RENESAS TECHNICAL UPDATE

Product Category	MPU/MCU		Document No.	TN-RX*-A0226A/E	Rev.	1.00
Title	Errata to User's Manual: Hardware Regarding the I ² C-bus Interface (RIIC)		Information Category	Technical Notification		
Applicable Product	RX630 Group, RX63N Group, RX631 Group, RX63T Group	Lot No.	Reference Document	RX630 Group User's Manual: Hardware Rev.1.60 (R01UH0040EJ0160) RX63N Group, RX631 Group User's Manual: Hardware Rev.1.80 (R01UH0041EJ0180) RX63T Group User's Manual: Hardware Rev.2.20 (R01UH0238EJ0220)		
		All

This document describes corrections to the "I²C Bus Interface (RIIC)" chapter in User's Manual: Hardware for the applicable products.

Figure 33.28 Set/Clear Timing of the AASy and DID Flags during Reception of Device-ID Address

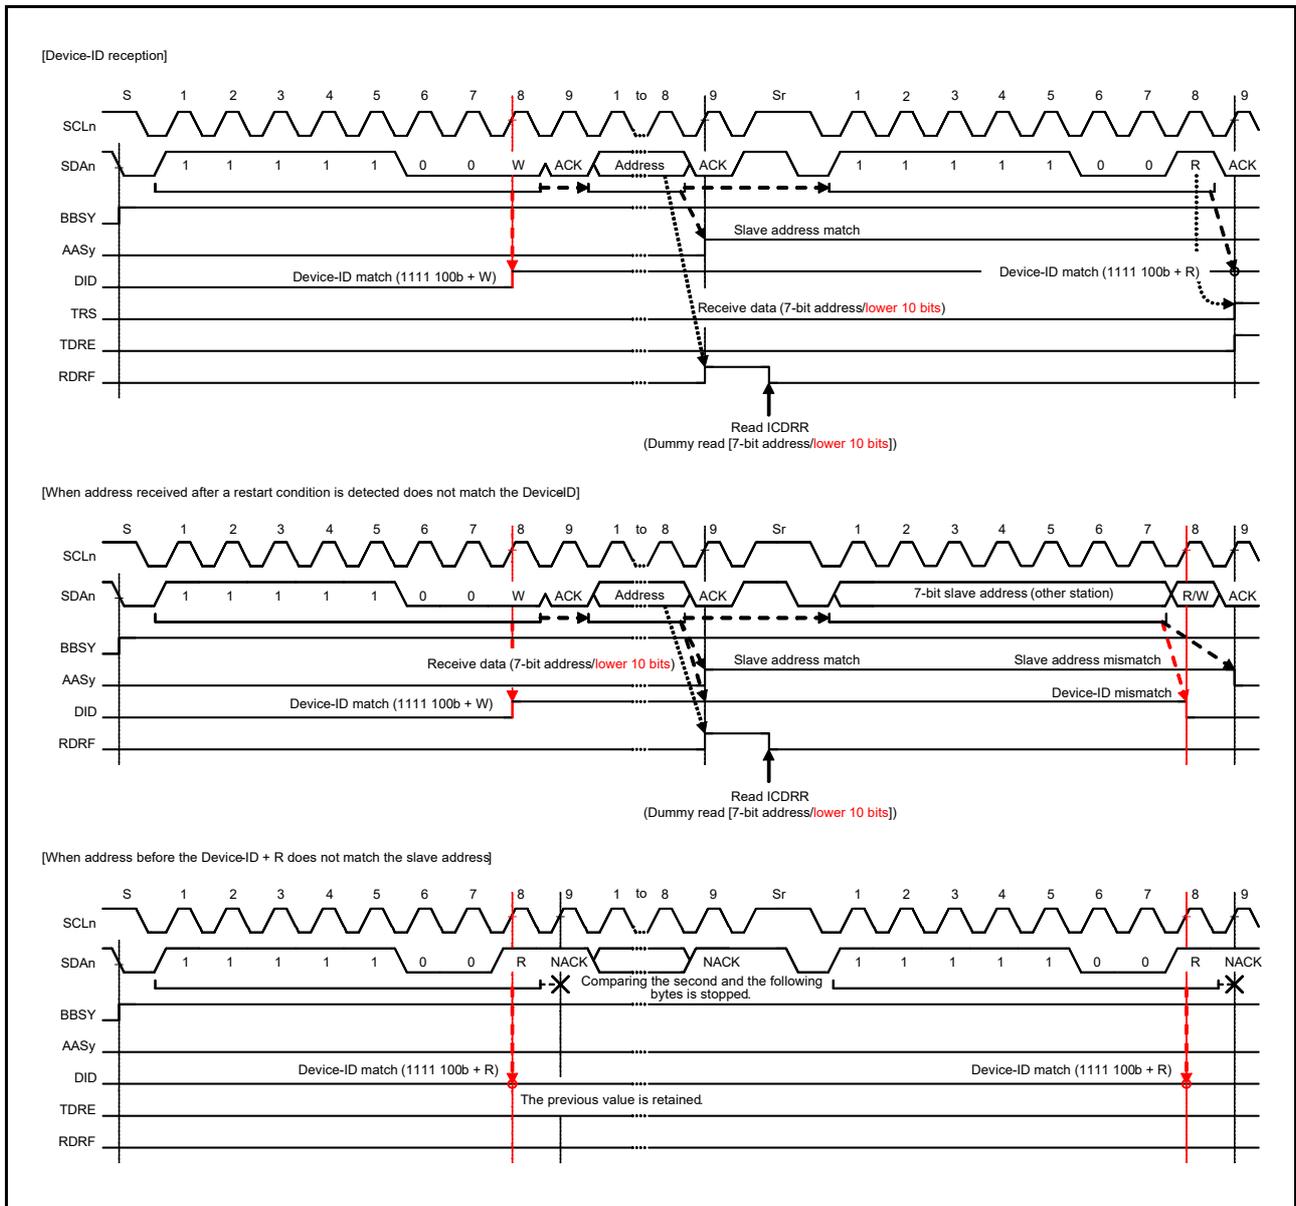
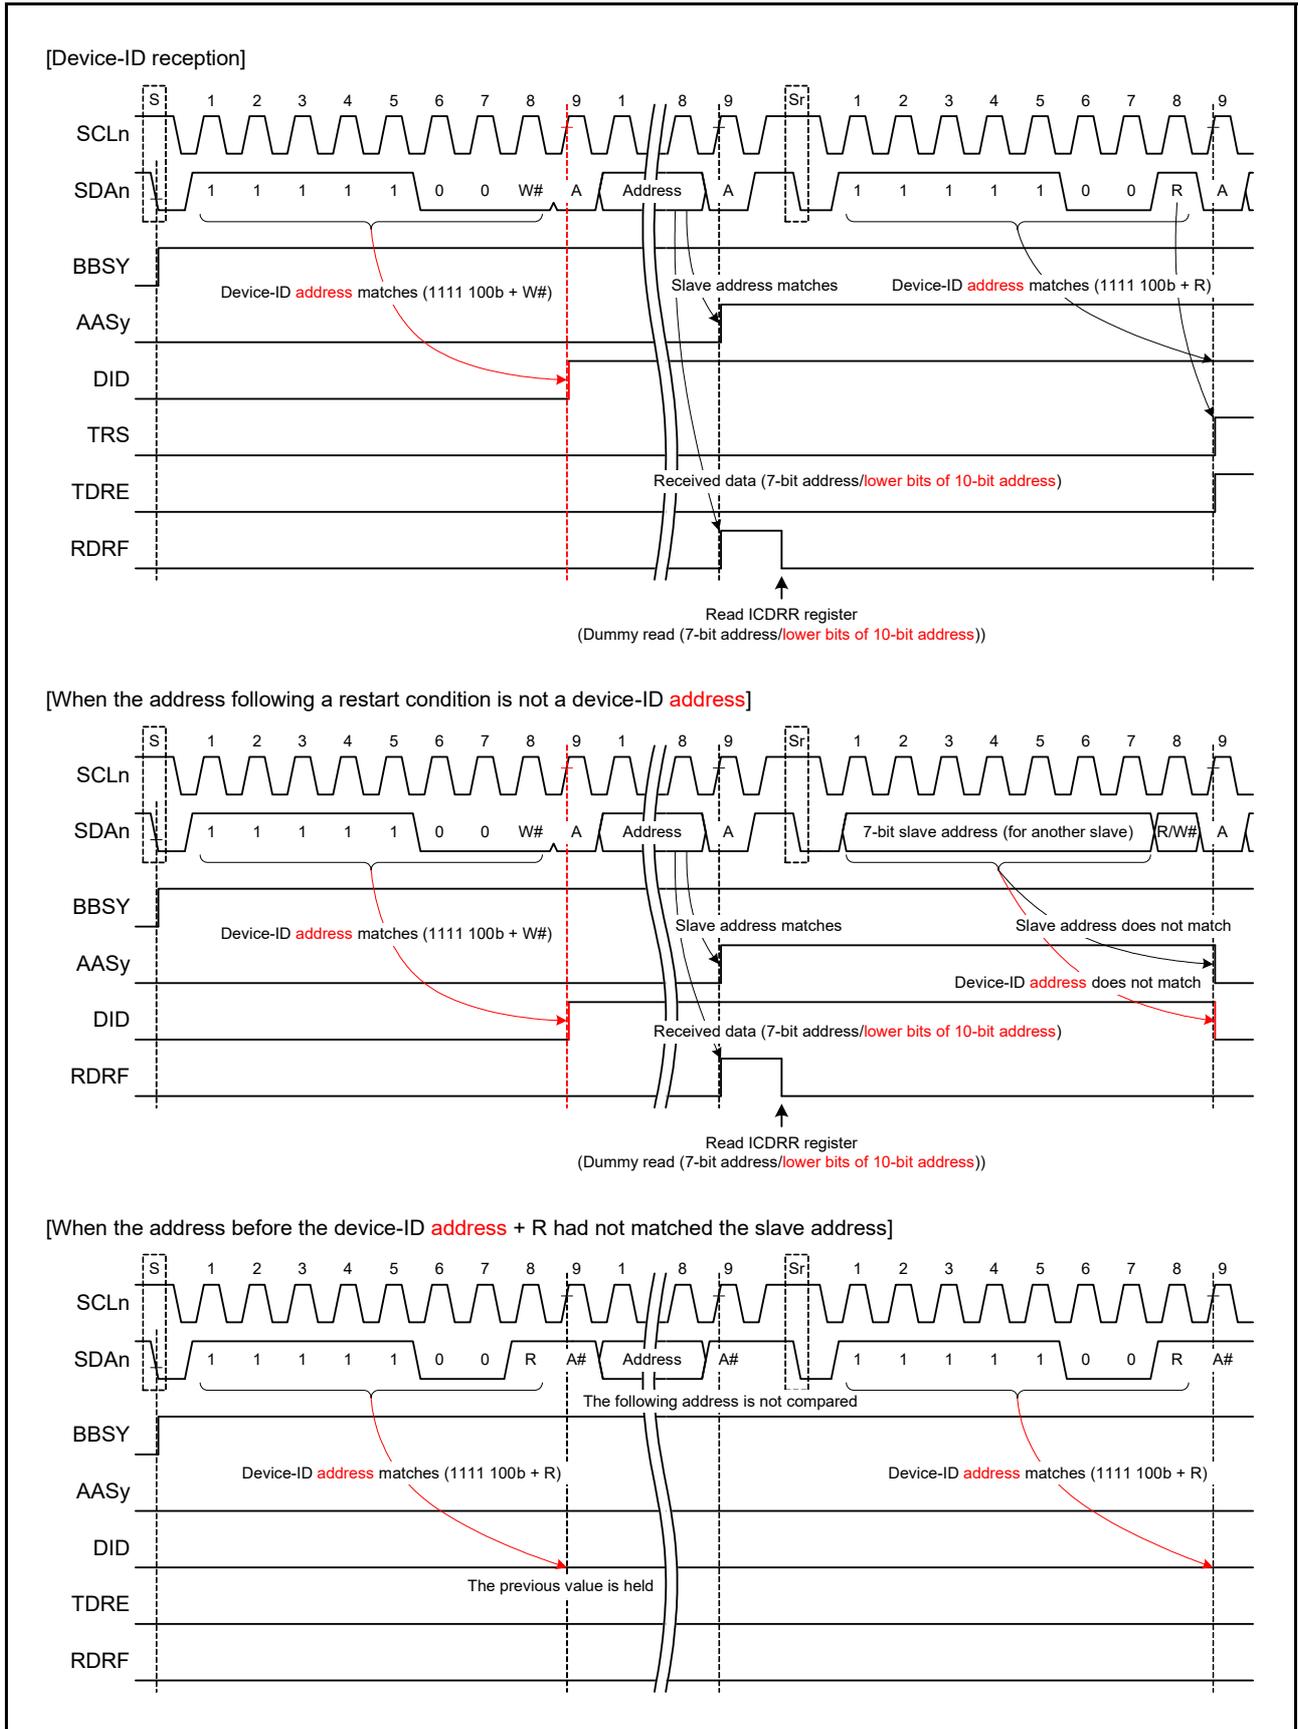
Figure 33.28 in section 33.7.3, Device-ID Address Detection is corrected as follows.

Figure 33.31 Suspension of Data Transmission When NACK is Received (NACK = 1)

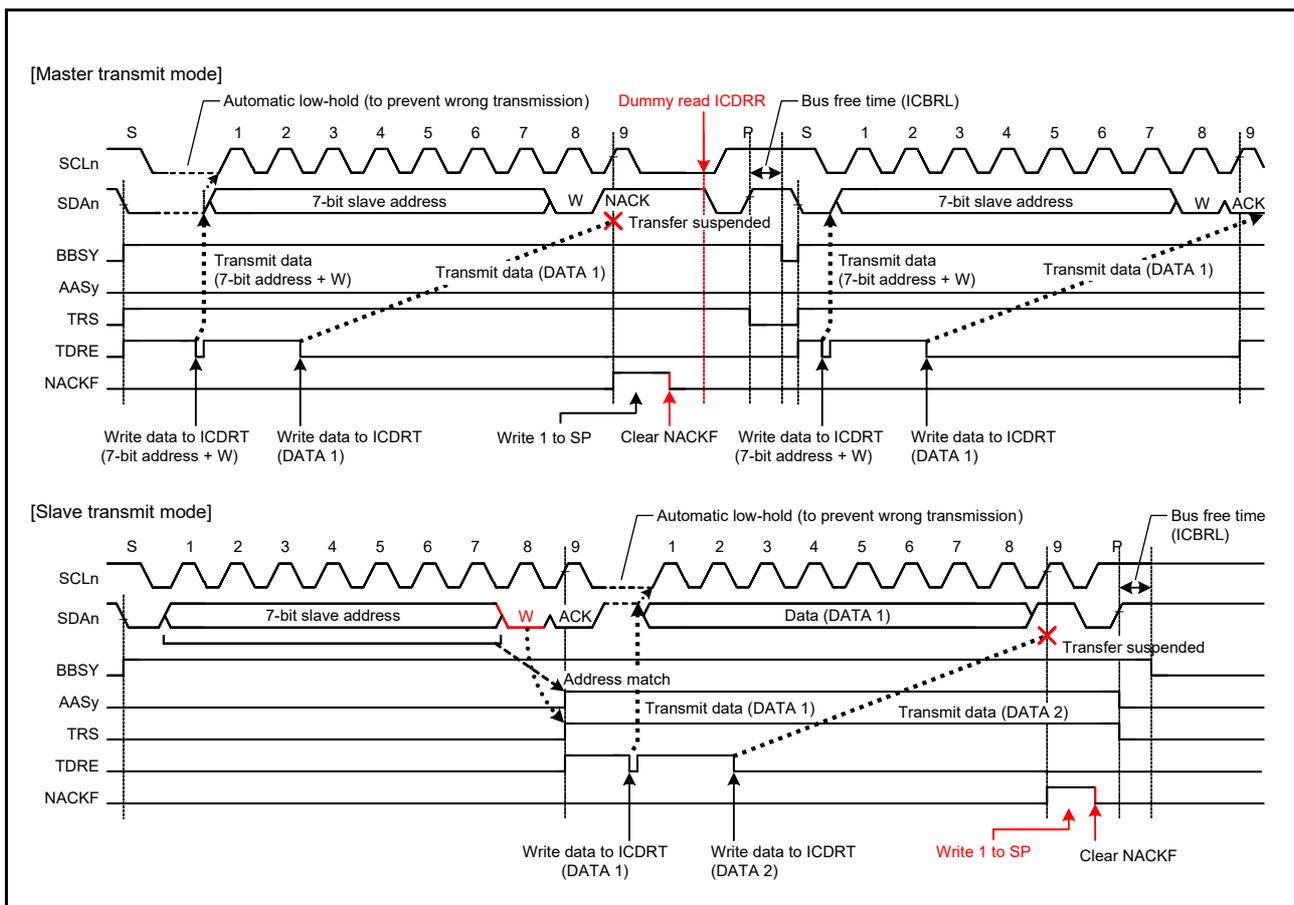
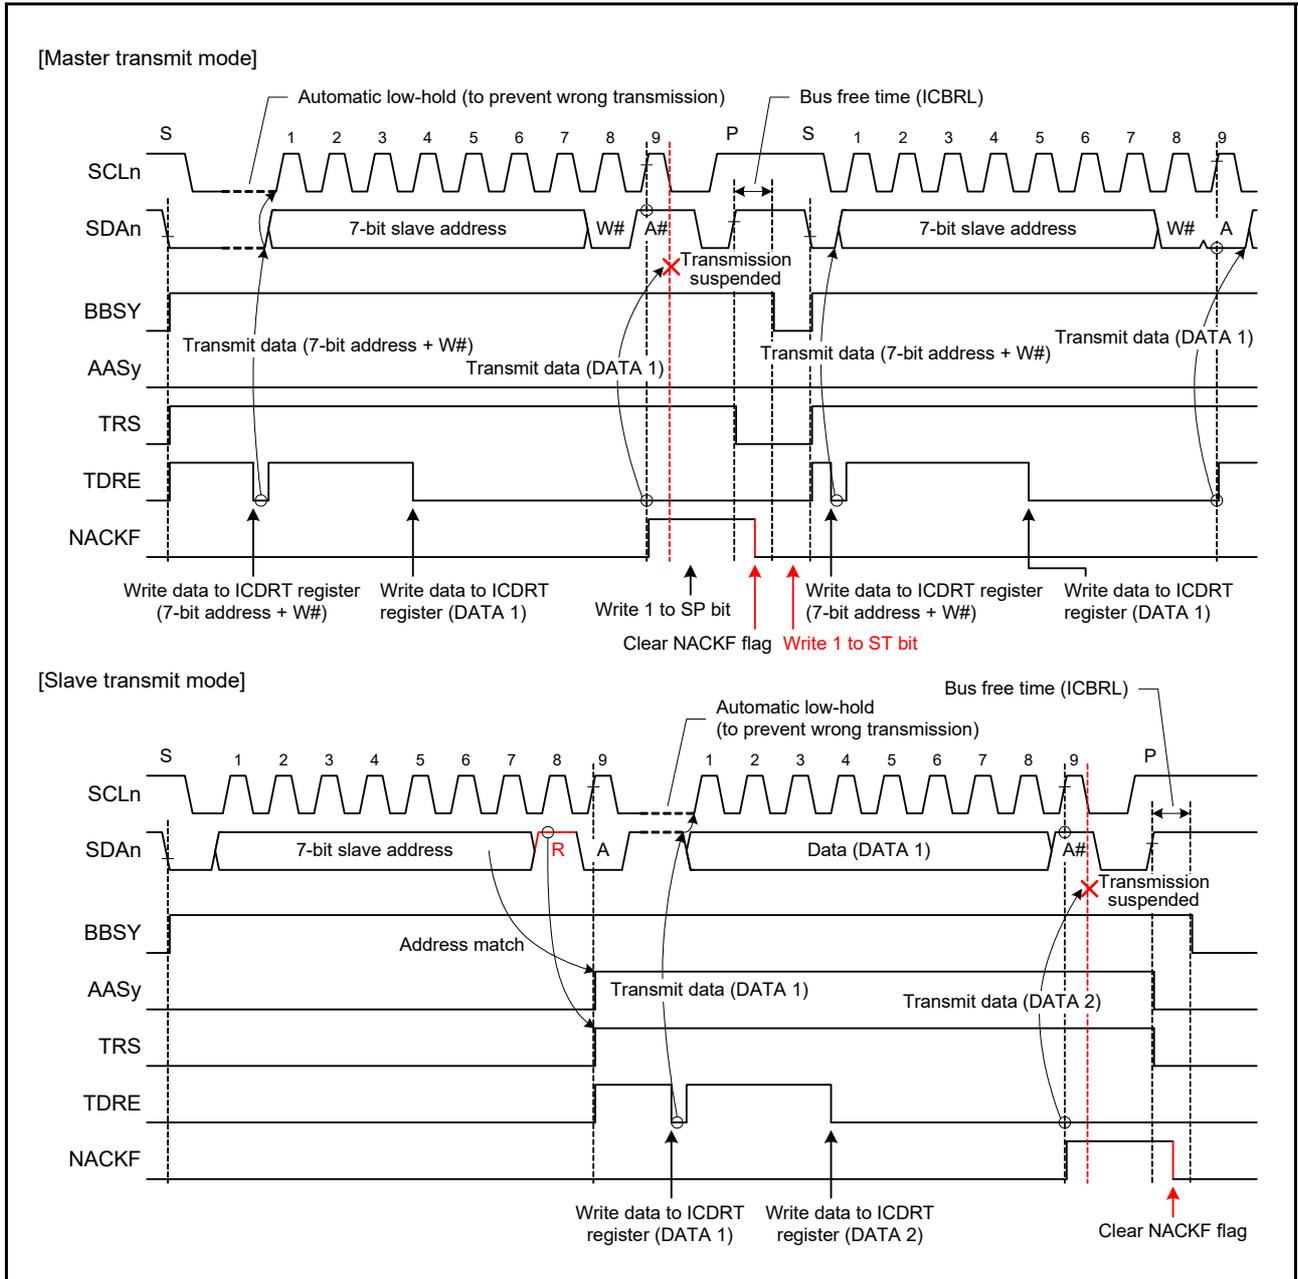
Figure 33.31 in section 33.8.2, NACK Reception Transfer Suspension Function is corrected as follows.

Figure 33.40 Additional SCL Output Function (CLO Bit)

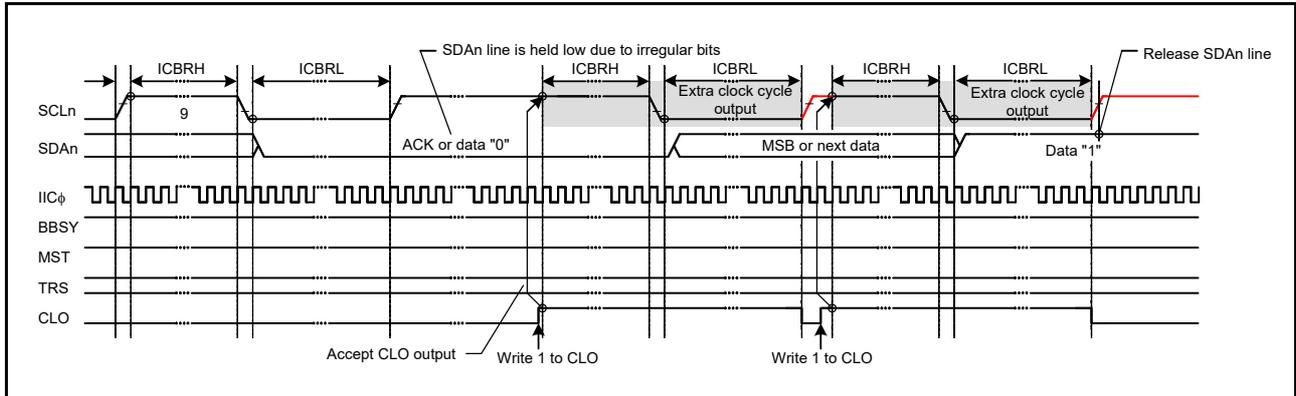
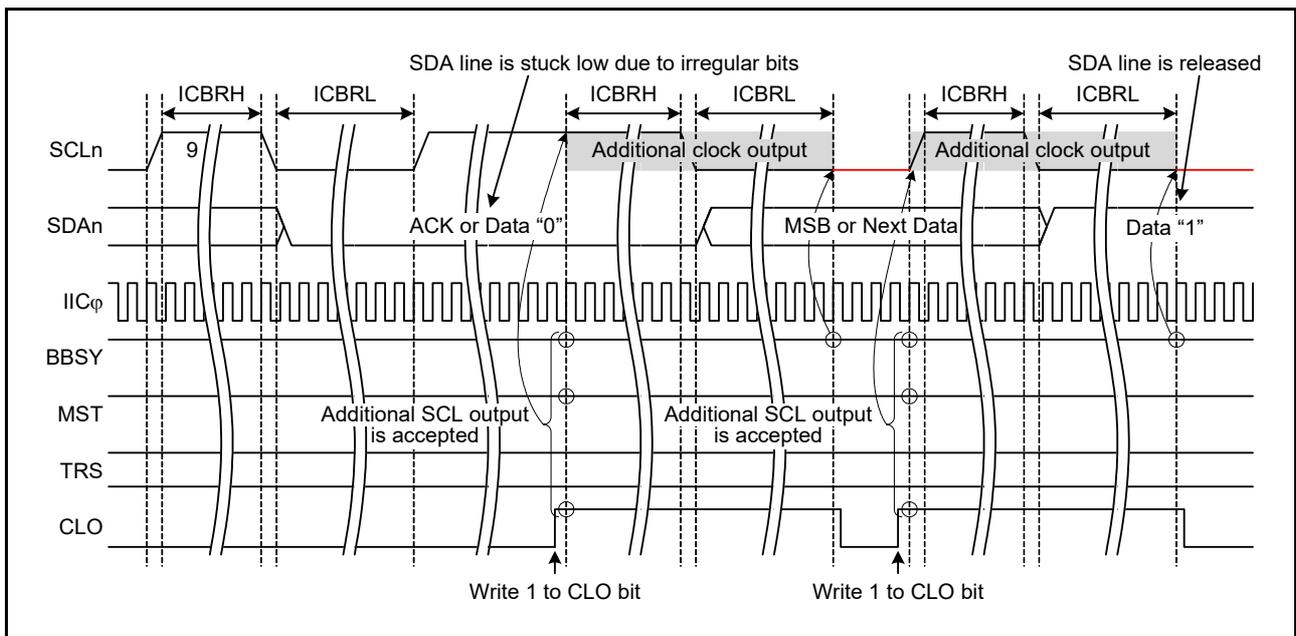
Figure 33.40 in section 33.11.2, Extra SCL Clock Cycle Output Function is corrected as follows.
